PRODUCT/PROCESS CHANGE NOTICE (PCN)

PCN #: **TB1503-01 (R1)** DATE: **October 23, 2015**
 Product Affected: **TSSOP-20, TSSOP-24, TSSOP-28,**
 TSSOP-48, TSSOP-56, TVSOP-48
 SOIC-28, SSOP-20, SSOP-28,
 (Refer to Attachment II for affected part# shipped in Reel)
 Date Effective: **February 1, 2016 Earliest Date - Refer to**
 specific date by package type

ATTACHMENT I - PCN #: TB1503-01 (R1)

Detail of Change: This notification is to advise our customers that IDT has planned to standardize the carrier tape on the selective package types to only one type as detailed below.

Figure 1: Additional Label pasted on ESD/Moisture barrier bag and Pizza box

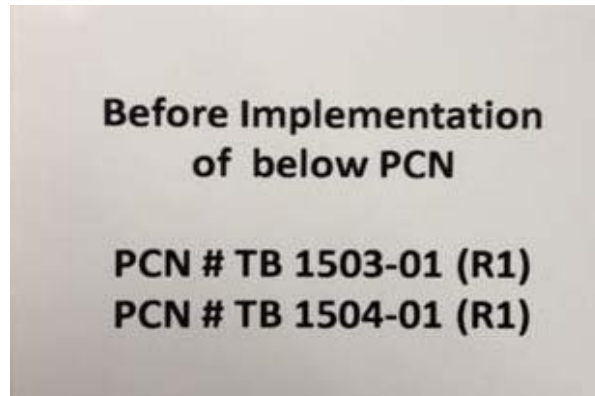
Customers may expect to receive shipments of products in new packing no sooner than 90 days from the date of this PCN notification. Shipments to customers may contain products shipped with either the existing packing or new packing during the transition period. Shipments made in the existing packing after the PCN becomes effective will have an additional label pasted on the ESD/moisture barrier bag and pizza box.

Illustration of Carrier Tape Pocket Design Change

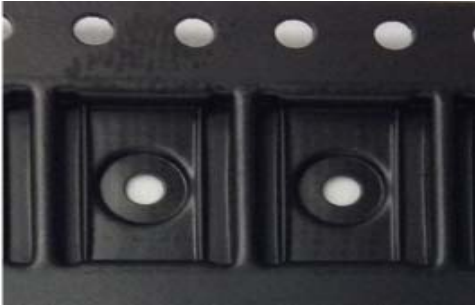
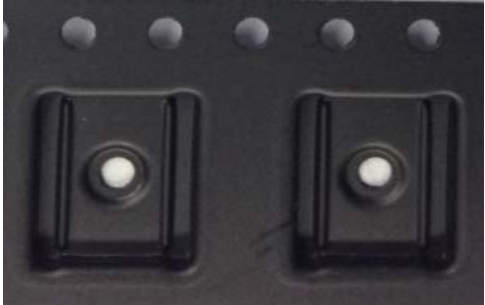
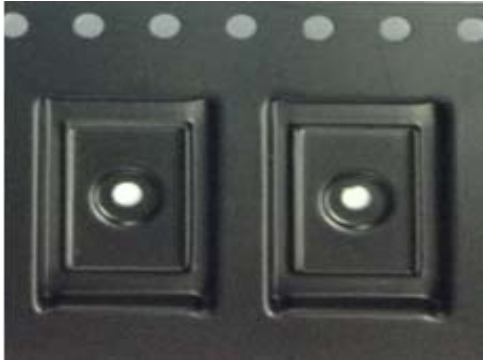
Package	From	To
TSSOP-20	Carrier Tape Part# P8-464-000 	Carrier Tape Part# P8-291-P20 
TSSOP-24	Carrier Tape Part# P8-329-P24 	Carrier Tape Part# P8-169-P24 
TSSOP-48	Carrier Tape Part# P8-260-P48 	Carrier Tape Part# P8-324-P48

Description	From	To
IDT Carrier Tape Part#	P8-464-000	P8-291-P20
IDT Carrier Tape Drawing#	MSC-7521	MSC-7519
Supplier Carrier Tape Part#	PGG20-20B3-360C-SD	eCA1760-PS-BLK-350
Supplier	PCT	E-PAK
Pocket Width, Ao (mm)	7.15 ± 0.05	7.00 ± 0.10
Pocket Length, Bo (mm)	6.90 ± 0.05	7.00 ± 0.10
Pocket Depth, Ki (mm)	1.25 ± 0.05	1.30 ± 0.10
Pocket Pitch, P1 (mm)	12.0 ± 0.1	8.0 ± 0.1
Total Pocket Depth, Ko (mm)	1.55 ± 0.05	1.60 ± 0.10
Carrier Tape Width, W (mm)	16.0 +0.2/-0.1	16.0 +0.2/-0.1
Carrier Tape Thickness, T (mm)	0.30 ± 0.05	0.30 ± 0.05

Description	From	To
IDT Carrier Tape Part#	P8-329-P24	P8-169-P24
IDT Carrier Tape Drawing#	MSC-5914	MSC-3388
Supplier Carrier Tape Part#	TSSOP24L-20B3-360C-SD	TSS30P12GP-20B3-360-SD
Supplier	PCT	PCT
Pocket Width, Ao (mm)	6.85 ± 0.10	7.00 ± 0.10
Pocket Length, Bo (mm)	8.20 ± 0.10	8.20 ± 0.10
Pocket Depth, Ki (mm)	1.40 ± 0.10	1.30 ± 0.10
Pocket Pitch, P1 (mm)	8.00 ± 0.10	12.00 ± 0.10
Total Pocket Depth, Ko (mm)	1.70 ± 0.10	1.55 ± 0.10
Carrier Tape Width, W (mm)	16.0 +0.2/-0.1	16.0 +0.2/-0.1
Carrier Tape Thickness, T (mm)	0.30 ± 0.05	0.30 ± 0.05

Description	From	To
IDT Carrier Tape Part#	P8-260-P48	P8-324-P48
IDT Carrier Tape Drawing#	MSC-7388	MSC-7539
Supplier Carrier Tape Part#	TSS48P16GP-22B3-360C-SD	eCA1765-PS-BLK-350
Supplier	PCT	E-PAK
Pocket Width, Ao (mm)	8.45 ± 0.13	8.85 ± 0.10
Pocket Length, Bo (mm)	13.00 ± 0.13	12.90 ± 0.10
Pocket Depth, Ki (mm)	1.20 ± 0.10	1.30 ± 0.10
Pocket Pitch, P1 (mm)	16.00 ± 0.10	12.00 ± 0.10
Total Pocket Depth, Ko (mm)	1.60 ± 0.10	1.50 ± 0.10
Carrier Tape Width, W (mm)	24.0 +0.2/-0.1	24.0 +0.2/-0.1
Carrier Tape Thickness, T (mm)	0.30 ± 0.05	0.30 ± 0.05

Illustration of Carrier Tape Pocket Design Change

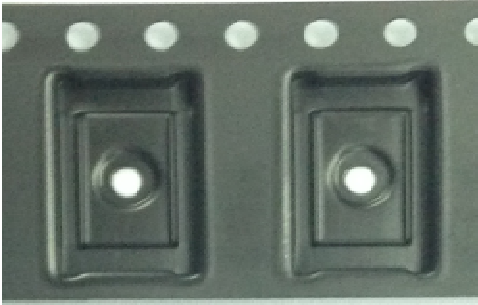
Package	From	To
SOIC-28	Carrier Tape Part# P8-187-S28 	Carrier Tape Part# P8-370-P28 
TSSOP-28 and TVSOP- 48	Carrier Tape Part# P8-145-PF8 	Carrier Tape Part# P8-330-P48 
TSSOP-56	Carrier Tape Part# P8-261-P56 	Carrier Tape Part# P8-314-P56

Description	From	To
IDT Carrier Tape Part#	P8-145-PF8	P8-330-P48
IDT Carrier Tape Drawing#	MSC-3196	MSC-5915
Supplier Carrier Tape Part#	TSS28/38GP-22B3-120-SD	TSSOP48LGP-22B7-120C-SD
Supplier	PCT	PCT
Pocket Width, Ao (mm)	6.90 ± 0.13	7.10 ± 0.10
Pocket Length, Bo (mm)	10.10 ± 0.13	10.10 ± 0.10
Pocket Depth, Ki (mm)	1.30 ± 0.10	1.30 ± 0.10
Pocket Pitch, P1 (mm)	12.00 ± 0.10	12.00 ± 0.10
Total Pocket Depth, Ko (mm)	1.50 ± 0.10	1.50 ± 0.10
Carrier Tape Width, W (mm)	16.00 ± 0.30	24.0 +0.2/-0.1
Carrier Tape Thickness, T (mm)	0.30 ± 0.05	0.30 ± 0.05

Description	From	To
IDT Carrier Tape Part#	P8-261-P56	P8-314-P56
IDT Carrier Tape Drawing#	MSC-7398	MSC-7543
Supplier Carrier Tape Part#	PA56SGP-22B3-360C-SD	eCA1764-PS-BLK-350
Supplier	PCT	E-PAK
Pocket Width, Ao (mm)	8.45 ± 0.13	8.85 ± 0.10
Pocket Length, Bo (mm)	14.50 ± 0.13	14.60 ± 0.10
Pocket Depth, Ki (mm)	1.20 ± 0.13	1.30 ± 0.10
Pocket Pitch, P1 (mm)	16.00 ± 0.10	12.00 ± 0.10
Total Pocket Depth, Ko (mm)	1.60 ± 0.13	1.50 ± 0.10
Carrier Tape Width, W (mm)	24.0 ± 0.3	24.0 +0.2/-0.1
Carrier Tape Thickness, T (mm)	0.30 ± 0.05	0.30 ± 0.05

Description	From	To
IDT Carrier Tape Part#	P8-187-S28	P8-370-P28
IDT Carrier Tape Drawing#	MSC-3405	MSC-5938
Supplier Carrier Tape Part#	SO28NP-22B3-75C-SD	SO28W32-22B3-62C-SD
Supplier	PCT	PCT
Pocket Width, Ao (mm)	10.80 ± 0.10	10.90 ± 0.10
Pocket Length, Bo (mm)	18.55 ± 0.10	18.55 ± 0.10
Pocket Depth, Ki (mm)	2.60 ± 0.10	2.70 ± 0.10
Pocket Pitch, P1 (mm)	12.00 ± 0.10	16.00 ± 0.10
Total Pocket Depth, Ko (mm)	3.00 ± 0.10	3.10 ± 0.10
Carrier Tape Width, W (mm)	24.0 ± 0.3	32.0 ± 0.3
Carrier Tape Thickness, T (mm)	0.30 ± 0.05	0.30 ± 0.05

Illustration of Carrier Tape Pocket Design Change

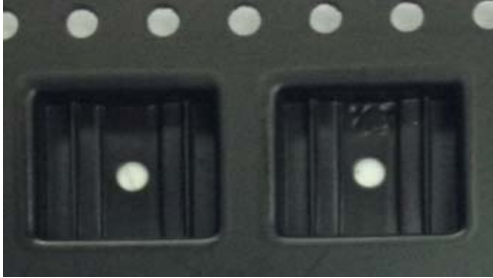
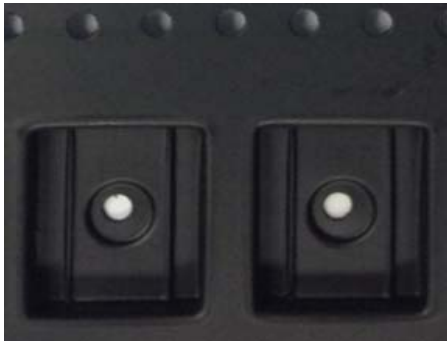
Package	From	To
SSOP-20	Carrier Tape Part# P8-259-P20 	Carrier Tape Part# P8-320-P20 
SSOP-28	Carrier Tape Part# P8-384-P28 	Carrier Tape Part# P8-321-P28

Description	From	To
IDT Carrier Tape Part#	P8-259-P20	P8-320-P20
IDT Carrier Tape Drawing#	MSC-7395	MSC-5909
Supplier Carrier Tape Part#	SSOP20SGP-22B3-360C-SD	SSOP20GP-22B3-80C-SD
Supplier	PCT	PCT
Pocket Width, Ao (mm)	8.20 ± 0.10	8.60 ± 0.10
Pocket Length, Bo (mm)	7.50 ± 0.10	7.60 ± 0.10
Pocket Depth, Ki (mm)	2.10 ± 0.10	2.00 ± 0.10
Pocket Pitch, P1 (mm)	12.00 ± 0.10	12.00 ± 0.10
Total Pocket Depth, Ko (mm)	2.50 ± 0.10	2.30 ± 0.10
Carrier Tape Width, W (mm)	16.0 ± 0.3	16.0 ± 0.3
Carrier Tape Thickness, T (mm)	0.30 ± 0.05	0.30 ± 0.05

Description	From	To
IDT Carrier Tape Part#	P8-384-P28	P8-321-P28
IDT Carrier Tape Drawing#	MSC-7356	MSC-5910
Supplier Carrier Tape Part#	EIAJ14GP-22B3-75C-SD	SSOP28W24PGP-22B3-180C-SD
Supplier	PCT	PCT
Pocket Width, Ao (mm)	8.40 ± 0.10	8.90 ± 0.10
Pocket Length, Bo (mm)	10.70 ± 0.10	10.60 ± 0.10
Pocket Depth, Ki (mm)	2.10 ± 0.10	2.00 ± 0.10
Pocket Pitch, P1 (mm)	12.00 ± 0.10	12.00 ± 0.10
Total Pocket Depth, Ko (mm)	2.40 ± 0.10	2.30 ± 0.10
Carrier Tape Width, W (mm)	16.0 ± 0.3	24.0 ± 0.3
Carrier Tape Thickness, T (mm)	0.30 ± 0.05	0.30 ± 0.05
